Contract #: 04-0120F4Cty: SF/ALA Rte: 80 PM: 13.2/13.9File #: 69.25B**QUALITY ASSURANCE -- NON-CONFORMANCE REPORT****Location:** Changxing Island, Shanghai, China**Report No:** NCR-000920**Prime Contractor:** American Bridge/Fluor Enterprises, a JV**Date:** 25-Nov-2010**Submitting Contractor:** Zhenhua Port Machinery Company, Ltd (ZPMC), Changxing Island**NCR #:** ZPMC-0882**Type of problem:**

Reference Description: New Welding Procedure Not Being Followed (Rager/McQuaid)**Description of Non-Conformance:**

Dear: Mr. Charles Kanapicki
Attention: Mr. Thomas Nilsson Project/Fabrication Manager
Subject: NCR No. ZPMC-0882

Job Name: SAS Superstructure
Document No: 05.03.06-000877

The weld is identified as FB3343-001-337

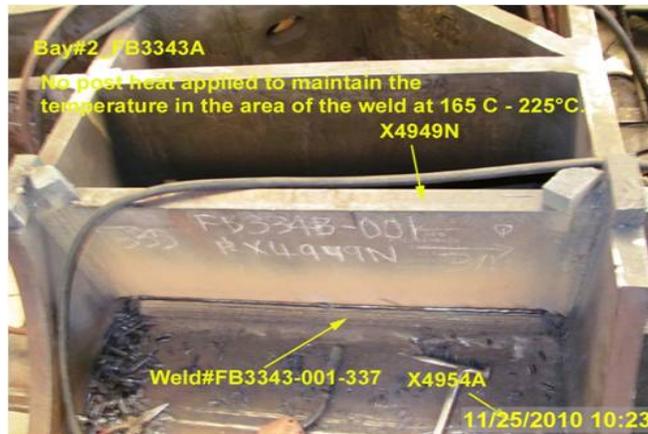
During Caltrans QA in process observations of the fabrication of FB3343A ,this QA discovered ZPMC welding personnel appear to not be following the NEW WELD PROCEDURE (Rager/McQuaid)

The following requirements were not followed:

5. Postweld Thermal Treatment (5A, 5C, 5D)

The area was being preheated using electric strip heaters.

The weld is a Complete Joint Penetration with steel backing joining FB web plate (X4954A) to Stiffener plate (X4949N).

The FB web base material thickness is 50 mm and stiffener plate is 45 mm.

Reference Resolution: As this NCR was written without a contractual basis it should be withdrawn.

The "NEW WELD PROCEDURE (Rager/McQuaid)" quoted as the basis for this NCR is not a contract document only a recommendation from the QA/QC Committee. If the Department wants to incorporate the QA/QC committee's recommendations as a contract requirement a contract change order should be issued. As this NCR was written without a contractual basis it should be withdrawn.

CT acknowledges contractor's response. However, successful NDT will close this NCR.

See attached NDT results to show the weld is acceptable. Based on this ZPMC requests closure of this NCR.

This proposed resolution is acceptable. The documentation received is sufficient and the Department concurs that Non-Conformance ZPMC-0882 is closed.

The weld is identified as FB3343-001-337

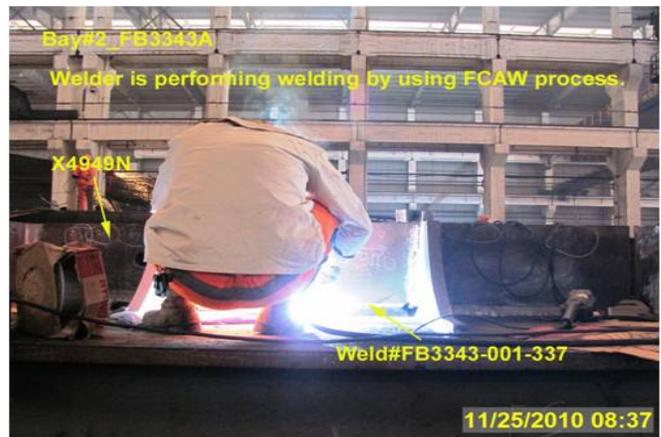
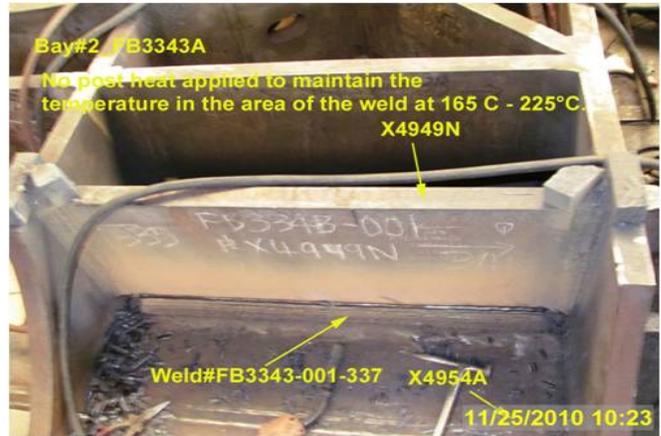
During Caltrans QA in process observations of the fabrication of FB3343A, this QA discovered ZPMC welding personnel appear to not be following the NEW WELD PROCEDURE (Rager/McQuaid)

The following requirements were not followed:

5. Postweld Thermal Treatment (5A, 5C, 5D)

The area was being preheated using electric strip heaters.

The weld is a Complete Joint Penetration with steel backing joining FB web plate (X4954A) to Stiffener plate (X4949N).

The FB web base material thickness is 50 mm and stiffener plate is 45 mm.

Contractor will provide the NDT report to prove the weld is acceptable.

Contractor provided the NDT report. The NDT report proves the weld is acceptable.
